September 19, 2018

**Urgent: Important Safety Update**  
AFX<sup>®</sup> Endovascular AAA System

**Figure 4: Ensure Guidewire Is Not Caught Behind Stent Strut**

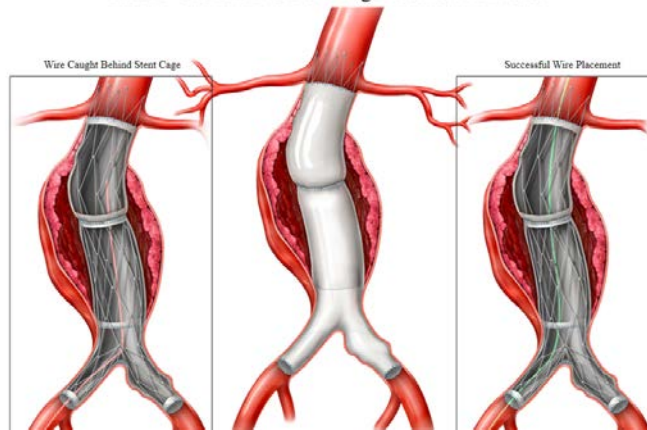
1. Refer to institutional protocols relating to anesthesia, anticoagulation and monitoring of vital signs.
2. Position patient on imaging table allowing fluoroscopic visualization from the aortic arch to the femoral bifurcations.
3. Gain luminal access through the femoral arteries.
4. Establish adequate proximal and distal vascular control of the surgically exposed femoral artery, as needed.
5. Following the manufacturer’s instructions for use, advance a flexible “J-tip” guidewire, pigtail catheter, or acceptable equivalent, into the vasculature under fluoroscopy.
  - NOTE: Proper device choice may limit the likelihood of tracking behind a stent strut. Reference **Figure 4**.

**Figure 5: Use of a Balloon to Confirm Correct Placement of Guidewire**

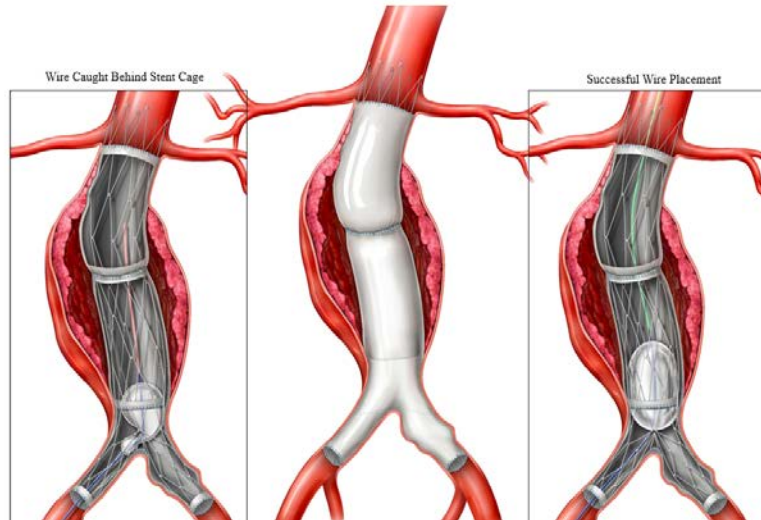
6. Once the flexible “J-tip” guidewire or pigtail catheter reaches above the existing AFX device, slowly advance an occlusion balloon or PTA balloon over the wire and under fluoroscopy. Slowly inflate, per the manufacturer’s instructions, until the balloon has been fully shaped or formed. It is recommended to use a 12mm diameter PTA balloon or an occlusion balloon that is partially inflated to ensure devices are not behind a stent strut.
  - Advance and retract the balloon catheter up and down the entire length of the existing AFX device to ensure there is proper luminal wire access.
    - NOTE: Balloon kinking during inflation or enlargement of a section of the stent cage may be a signal of a potential wire placed behind a stent strut. Reference **Figure 5**.
